To: T10 Technical Committee
From: SDV working group via Bill Ham (Bill.Ham@Compaq.com)
and Rob Elliott, Compaq Computer Corporation (Robert.Elliott@compaq.com)
Date: 10 September 2001
Subject: T10/01-149r2 SDV working group recommendations for changes to SPI-4

This document contains the recommendations of the SDV working group for changes to SPI-4 regarding the margin control mode page and ECP page and to define "driver-receiver connection" in the model.

Figure 1 - Device to device driver-receiver connections

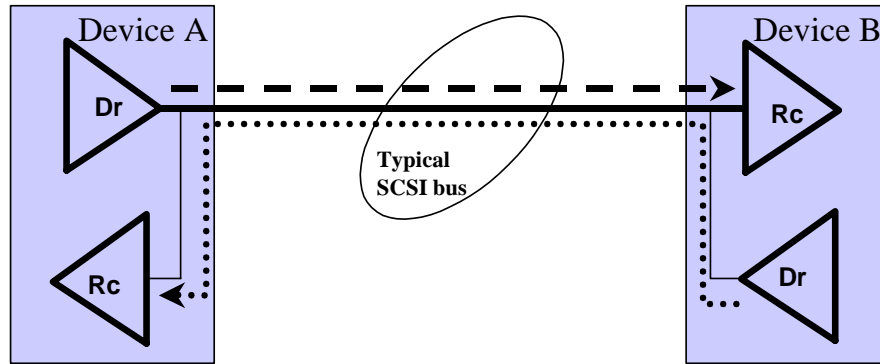
Figure 1 shows a portion of a single SCSI bus segment between two SCSI devices. Each device has a driver and a receiver for each signal. There may be other SCSI devices or terminators not shown in Figure 1 that are connected to the path between the driver and the receiver. Two driver-receiver connections exist between any two SCSI devices or simple expanders, one for each direction.

[\[Editor's note: change 20 signals line to "27 signals \(2 wires per signal on a differential bus\) – one signal shown"\]](#)

[\[Editor's note: remove "Typical SCSI bus" and ellipse\]](#)
